Subject: Addendum to Geotechnical Investigation Report  
Commercial Building  
37 South Water Street  
Henderson, Nevada

DEI No.: 18-0379

Reference: Geotechnical Investigation Report by DuPont Engineering, Inc. (Report No.: 18-0379, dated September 4, 2018)

**Net Allowable Uplift Capacity (Pier Diameter = 3 feet)**

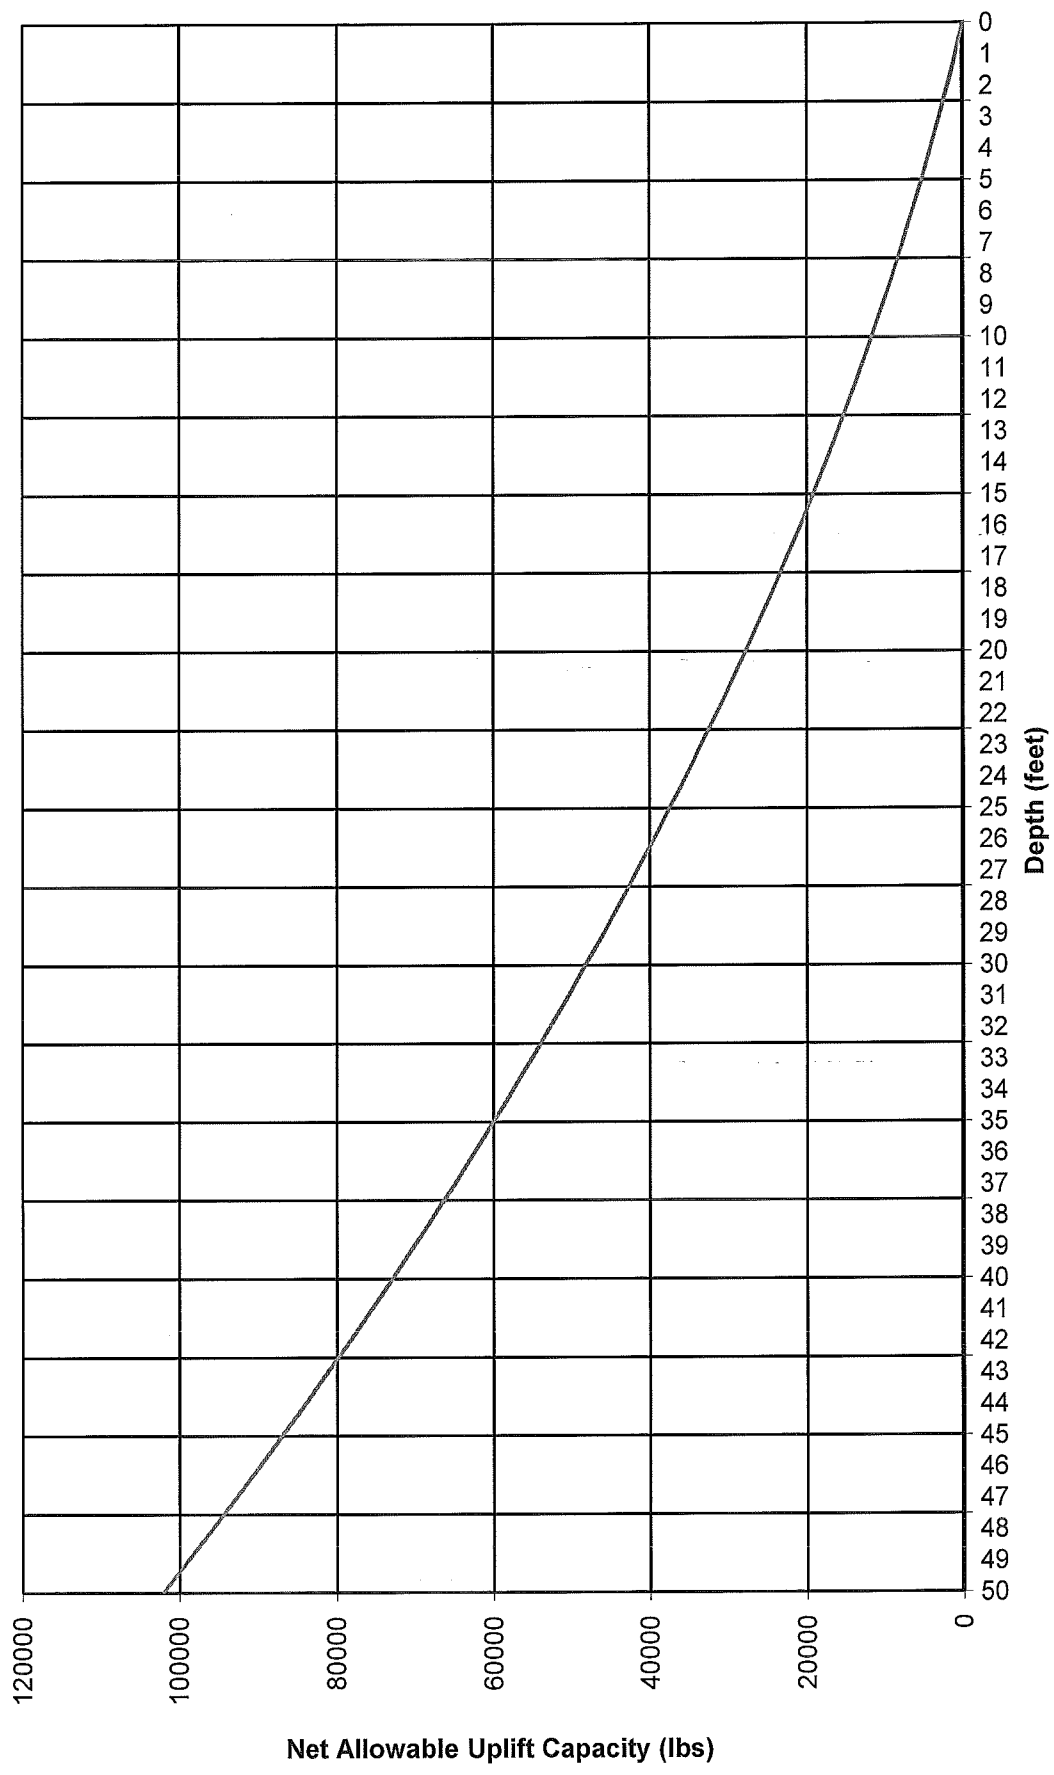
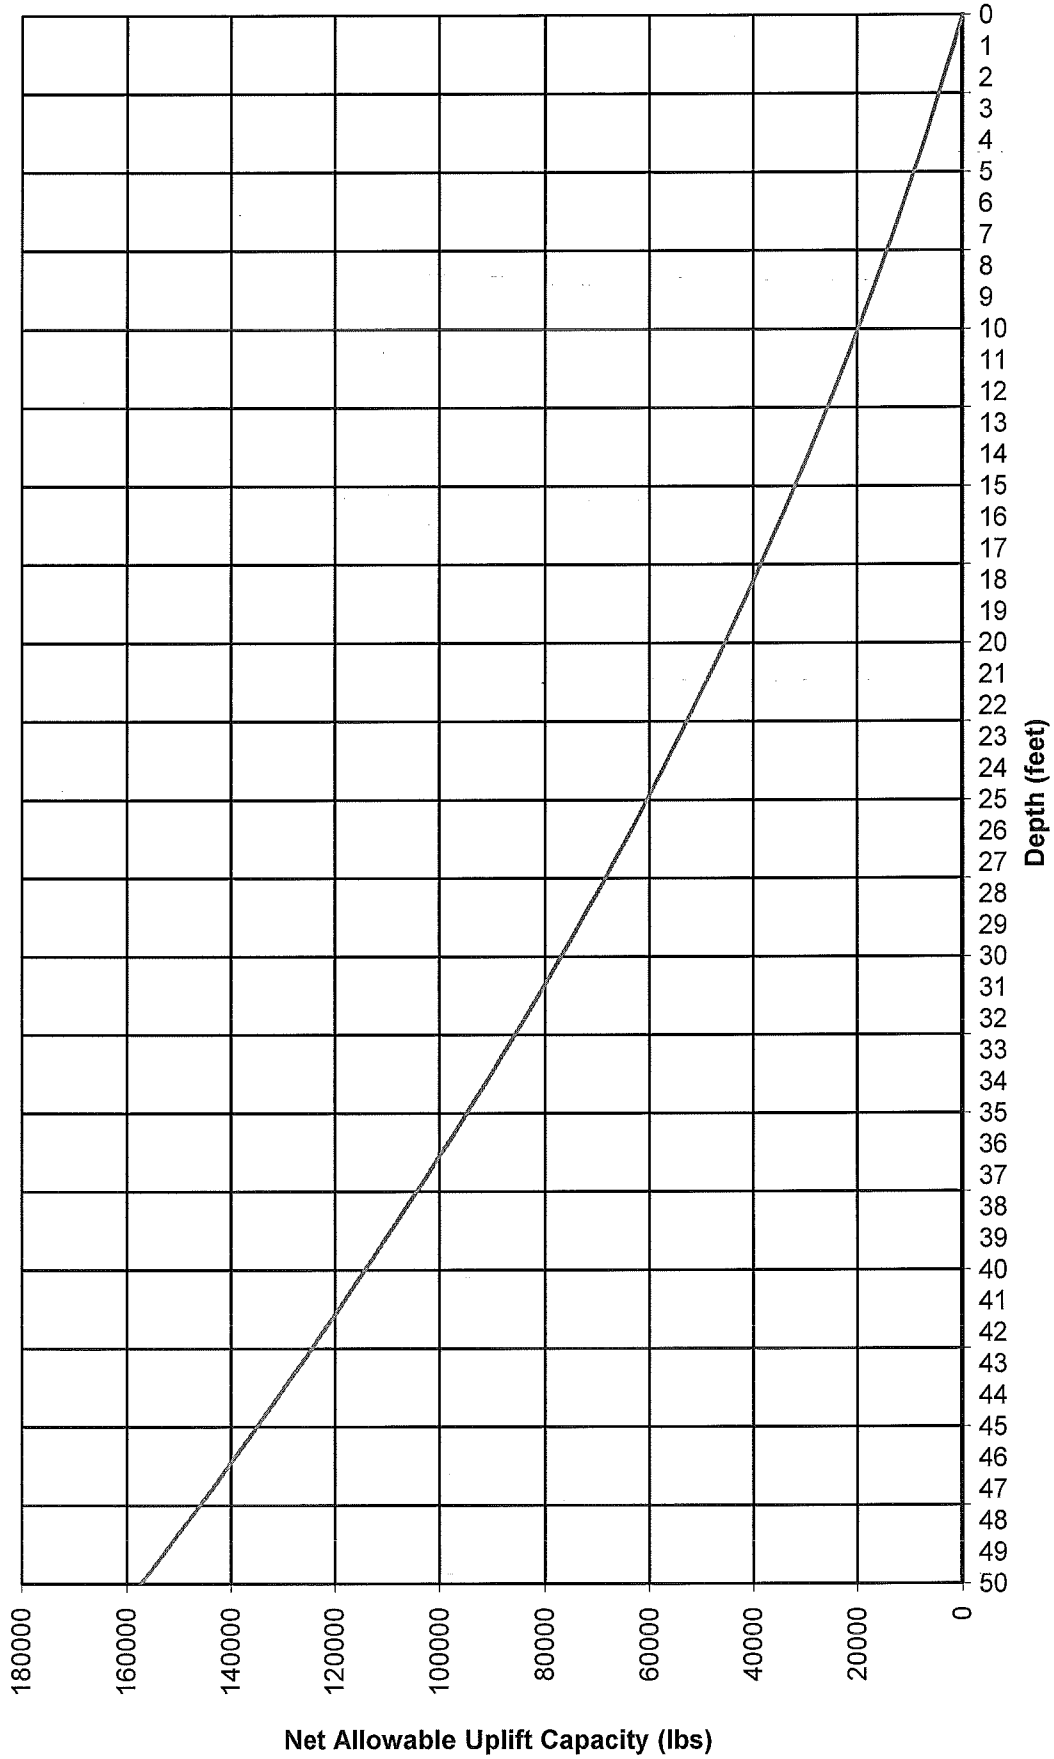
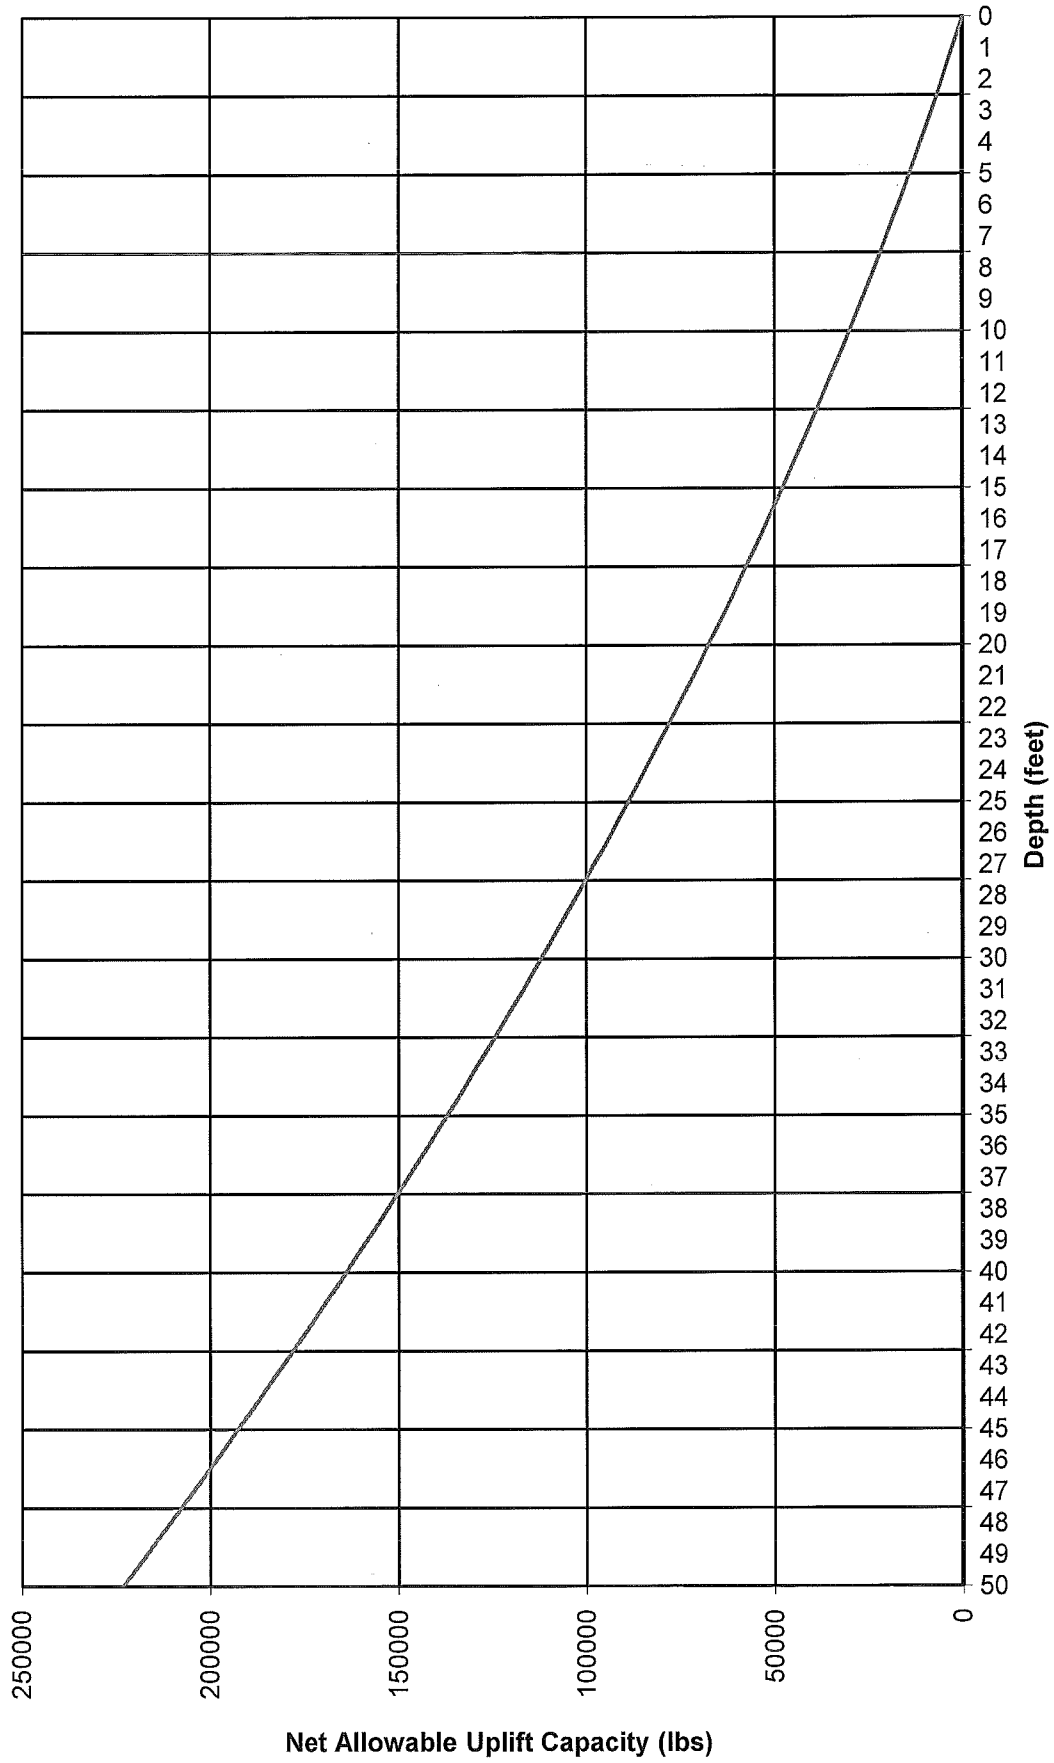
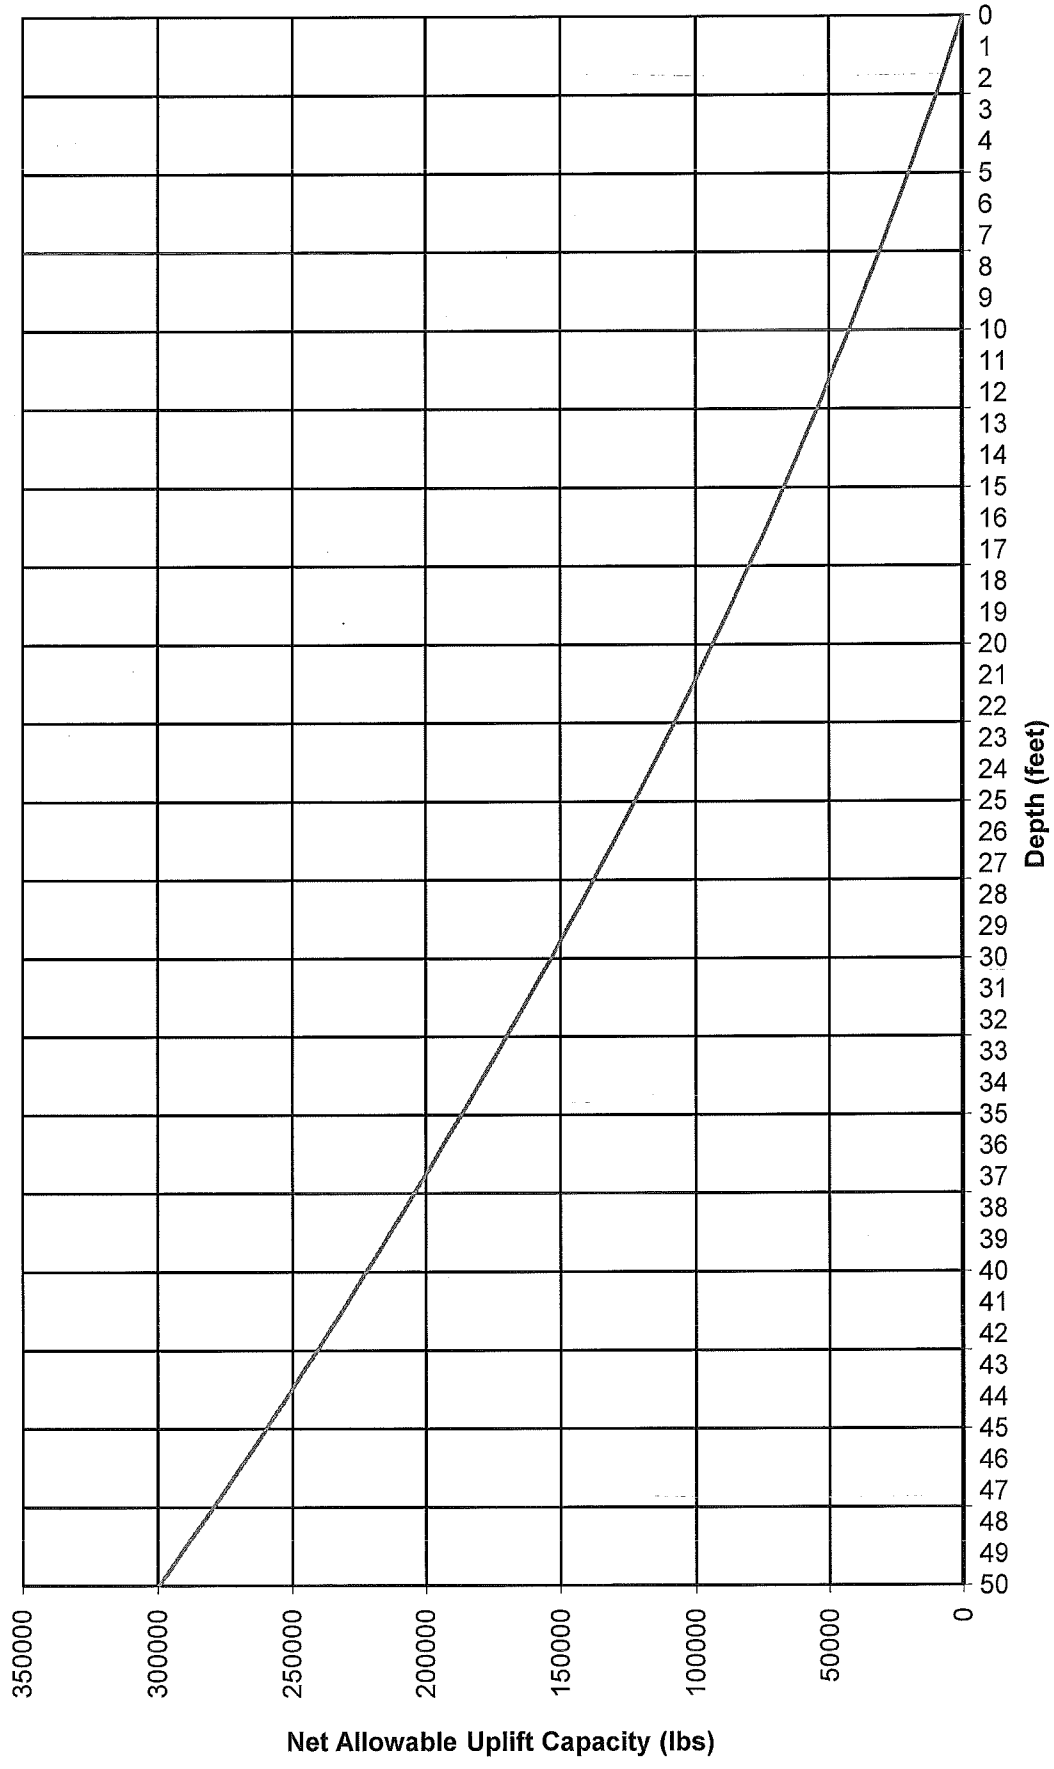
The net allowable downward and uplift capacities (the loads that may safely be placed upon the pier by the tower) have been graphed for several pier diameters and are attached. Factors of safety of 2.5 for downward capacity and 4.5 for Uplift Capacity have been applied.
